TECHNICAL MEMORANDUM

DATE: August 31, 2011 **PROJECT:** 1362.01
TO: Wayne Costa, TOWN OF FLORENCE
FROM: Michele Robertson and Dennis Hall
MONTGOMERY & ASSOCIATES

**SUBJECT: REVIEW OF CURIS RESOURCES (ARIZONA) INC. APPLICATIONS
PZC-32-11-MGPA and PZC-33-11-MGPA FOR GENERAL PLAN
AMENDMENTS FOR FLORENCE COPPER PROJECT, FLORENCE,
ARIZONA**

FIGURE 4. NRDAE OVERLAY

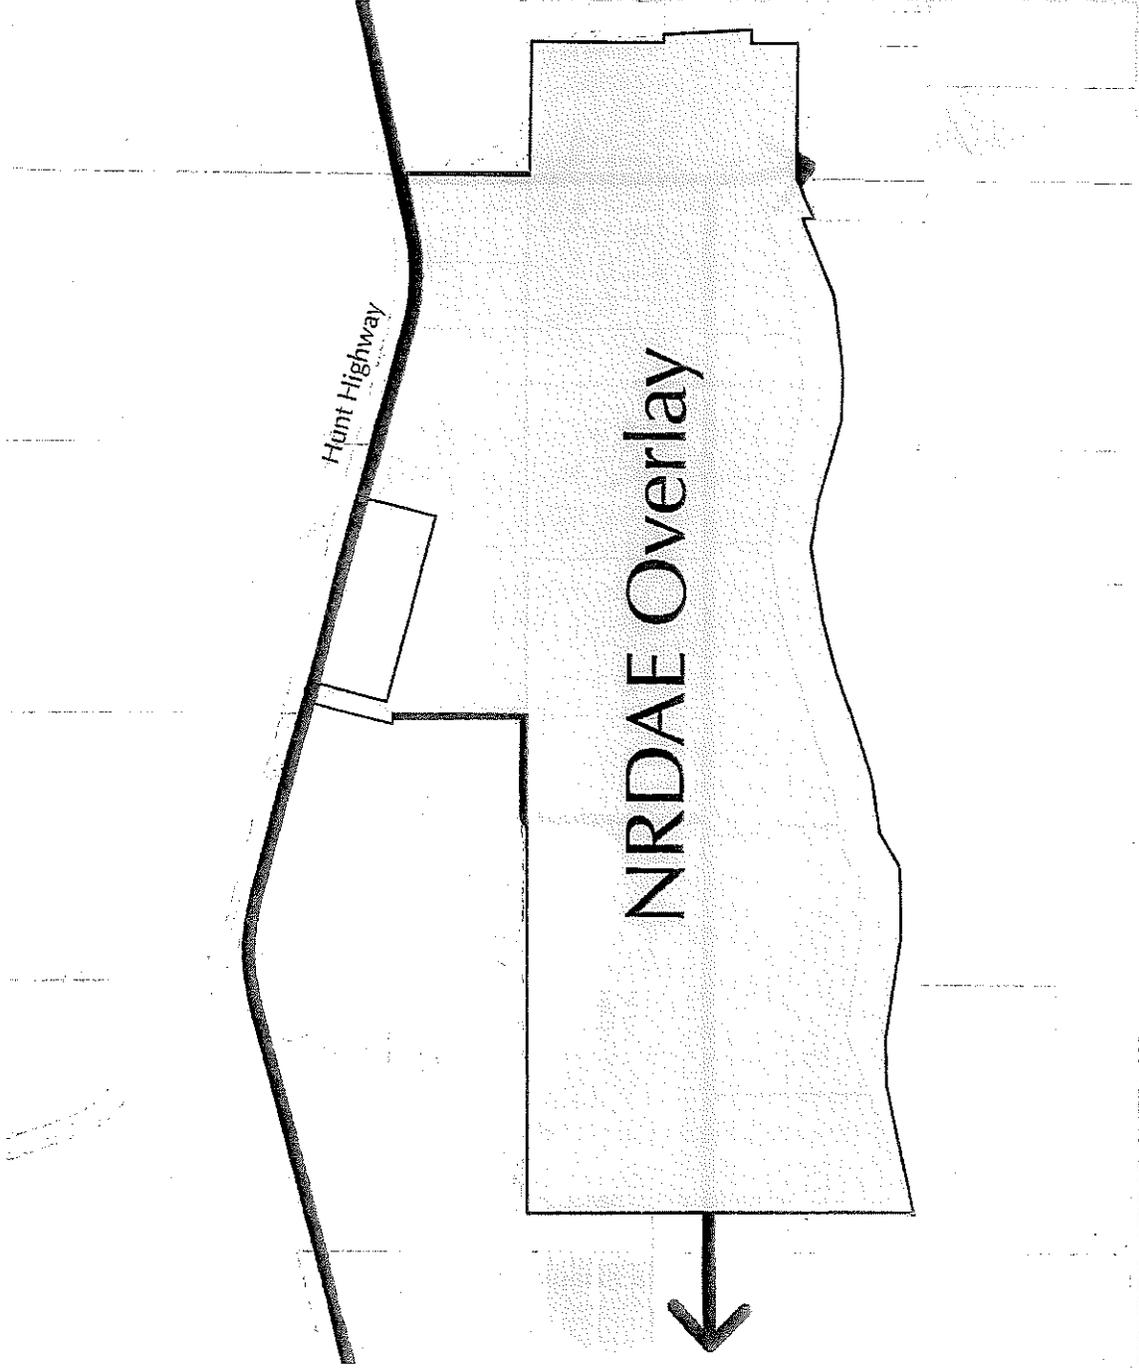
The PZC-33-11-MGPA application requests that the NRDAE overlay be applied to a portion of the Curis property that would be used for the ISCR operations. Curis owns 1,182 acres of land south of Hunt Highway. Of this land, the major general plan amendment application addresses only 990 acres. The portion of the property on the north, between Hunt Highway and the State

Trust Land, and a strip of land beneath the power line corridor on the west of the property are not included in this application **Figure 4**. Only 510 acres of the property would be used for ISCR operations with the balance (480 acres) available for other uses. The applicant requests that the NRDAE overlay be applied to the site to allow for development of the copper resources to occur in the immediate future (proposed First Life) and to allow for a return to the land uses similar to those identified in the General Plan in the more distant future (proposed Second Life). The First Life would last for approximately 20 years and comprise development of the ISCR project combined with a mix of recreational, educational, agricultural, and other uses outside of the ISCR area. The Second Life would occur following completion of ISCR mining operations and would be similar to the Merrill Ranch Planned Unit Development (PUD), but would have less dense residential development and more commercial, open space, and recreational areas.

FIGURE 5. RECHARGE AND PRODUCTION WELL LOCATIONS

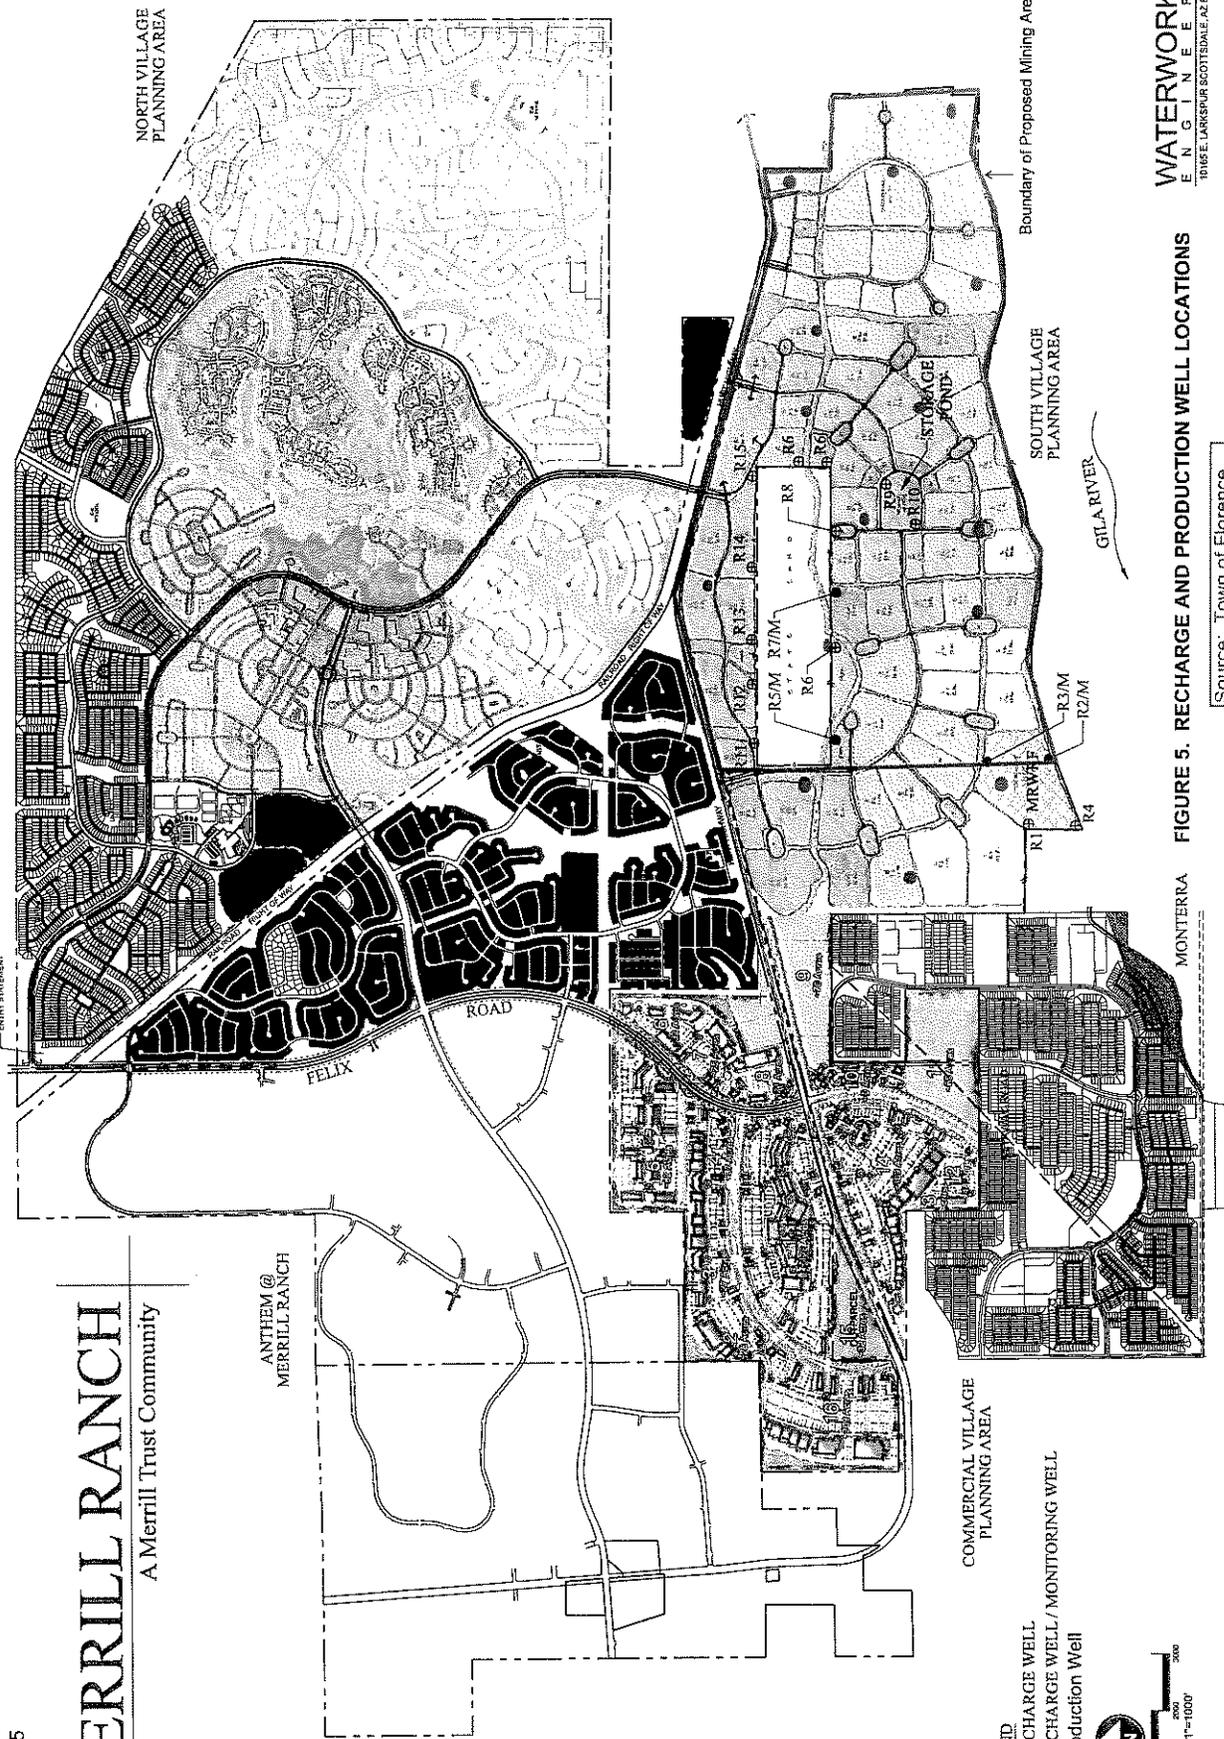
Two potential locations were provided by TOF for the potential future water reclamation facility for Merrill Ranch Master Planned Community. One of these locations has two options to provide for recharge of reclaimed water that would be generated at the proposed Merrill Ranch Water Reclamation Plant (**Figure 5**): one within the Curis property; and one adjacent to the Curis property. The option within the Curis property includes potential installation of vadose zone recharge wells around the boundary of the State Trust Land parcel. The State Trust land is included within the area that Curis proposes for ISCR operations. As a result, TOF is considering other locations for these recharge wells. If the ISCR operations proceed, recharge in this area would not be appropriate and the recharge wells would need to be relocated. Post-mining installation and use of vadose zone recharge wells within the mining area may potentially be acceptable following closure of the ISCR operations, but further hydrogeologic and groundwater quality evaluations would be required at that time prior to proceeding. The option for locating the water reclamation plant adjacent to the Curis property (southwest corner) also includes potential installation of vadose zone recharge wells. Additional potential production wells are shown in this area on **Figure 6**. If the ISCR operations proceed, recharge in this area may be appropriate, as the recharge operations may enhance the hydraulic containment of the ISCR leach solution; however, we recommend further hydrogeologic evaluations be conducted prior to proceeding with this option.

The FCP should have no impact on the ability of Florence to continue to maintain compliance with the Safe Drinking Water program. However, if Florence intends to install potable supply wells on the west side of the Curis property (**Figures 5 and 6**), it is suggested that the potential impact of wells in that location be incorporated into the groundwater model of the Curis ISCR impacts.
